STAFF REPORT: 9/10/2025 REGULAR MEETING

APPLICATION NUMBER: HDC2025-00476

ADDRESS: 14833 STAHELIN

SCOPE: EXPAND DRIVEWAY, DEMOLISH GARAGE, ERECT NEW GARAGE (WORK COMPLETED WITHOUT APPROVAL)

Detroit Parcel Viewer. Aerial view of Parcel 22083667, 14833 Stahelin (outlined in yellow), with the old garage visible in the southwest corner of the lot.

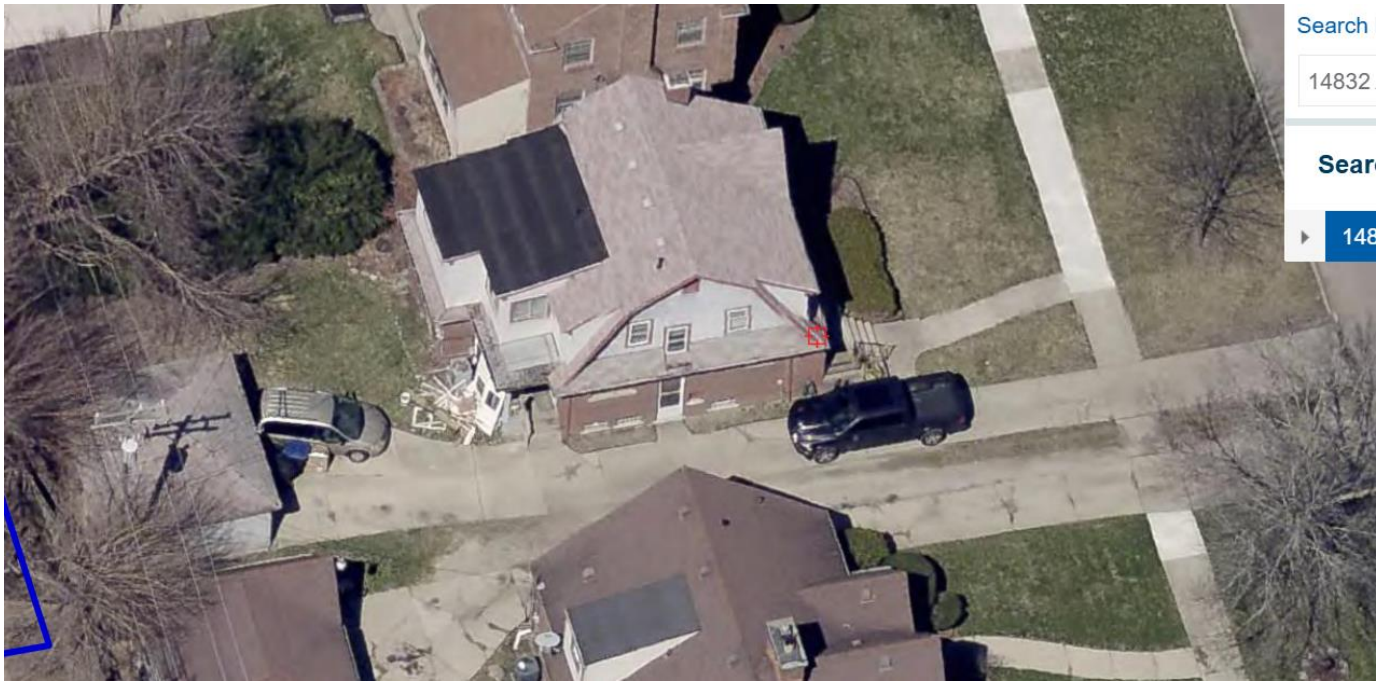
A driveway is along the house's south side. At the end of the drive behind the house's southwest corner is a garage, erected without permit. The garage is one story, 40 feet wide and 22 feet deep. From the sidewalk, a viewer can see a portion of the one-story garage and overhead door. Behind the house, however, the garage extends further. The historic garage (now demolished) was a modest, hipped-roof building built along with the house in 1928. In 2023, it was reported that the historic garage was demolished, a new driveway was installed, and a new garage was underway. That same year, this garage was proposed to the Historic District Commission and was denied (HDC2023-00091).

The 2009 Google streetview photo above shows that there was some cracking concrete in the old driveway. The new driveway is wider, and the new concrete pad behind the house eliminated any backyard greenspace. Those changes to the backyard cannot be seen from the front of the house. The new driveway is wider than the old, but staff does not think it is so noticeably different as to be demonstrably incompatible. Rosedale Park’s Elements of Design #13 (“*Relationship of significant landscape features and surface treatments*”) mention that there is typically a single-width driveway leading to a garage. The widened driveway is still single width.

Applicant-provided photo, completed garage, 2025, northeast corner and north elevation. The composite siding and unfinished plywood are visible. A window has been installed near the garage's northeast corner, as per the plan. Materials were not specified.

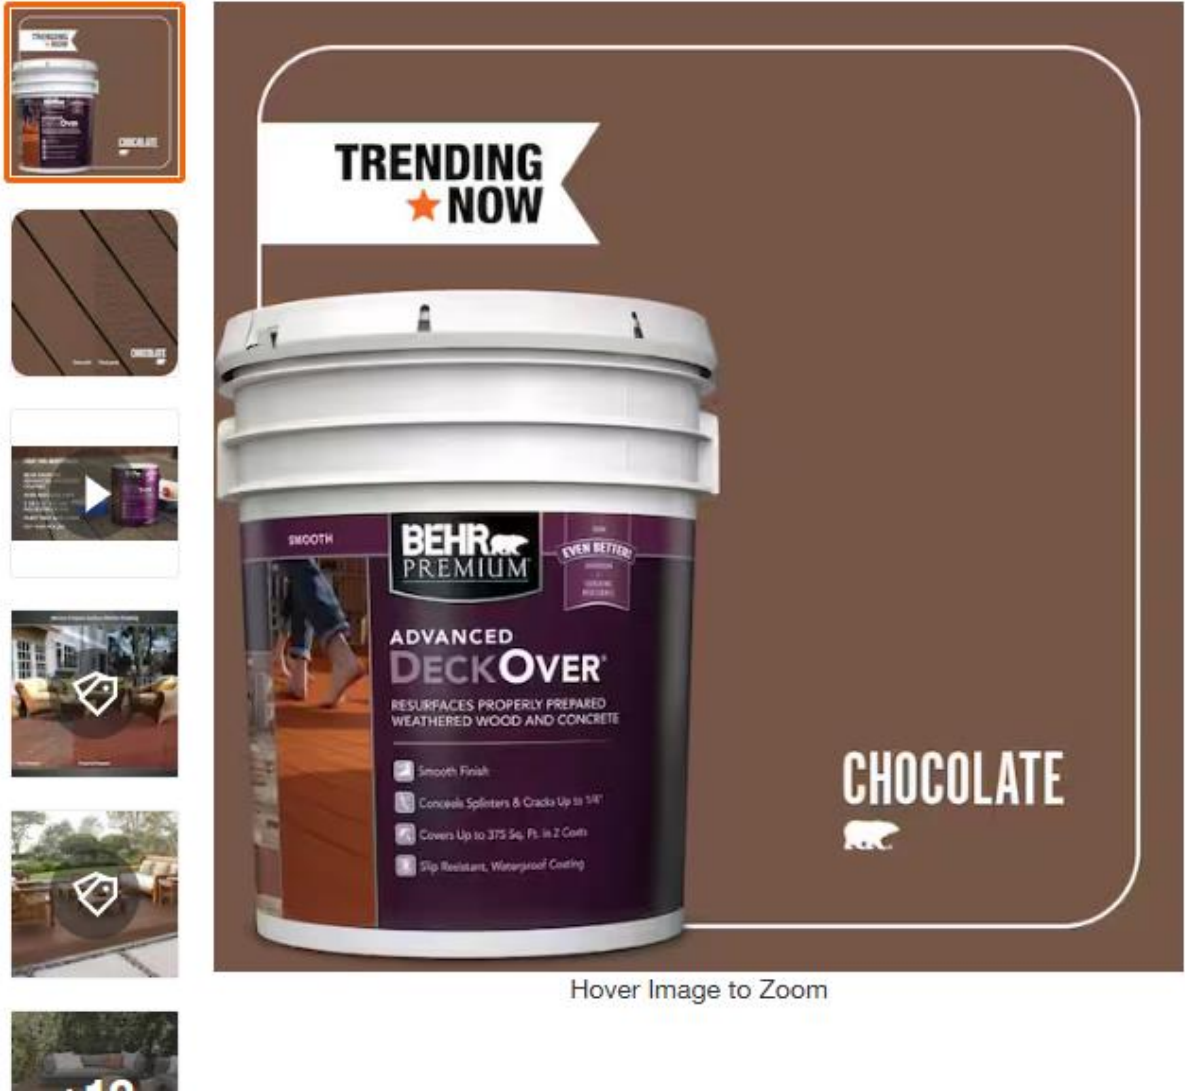
- While the application is generally complete, staff did note that the installed skylights were not mentioned in the proposal or plans, and that the product specs, colors, and materials were not included for the following elements:
 - soffits and fascia
 - windows (installed)
 - gutters and downspouts
 - skylights (installed)
 - sliding glass door

Also unclear is whether the unsided areas of the garage are planned to be sided. Staff contacted the applicant via email and requested that the above-listed information be submitted and asked about the unfinished areas.

- It is possible that once the materials are fully understood (for windows, soffits and fascia, gutters and downspouts, skylights, and sliding glass door, and whether any cladding for the visible plywood is proposed), the new garage will fail to meet Element of Design #7 as well.
- The proposed (now completed) concrete pad behind the house has removed all lawn/greenspace in the backyard, removing a character-defining feature of the property according to the district's Elements of Design #14.
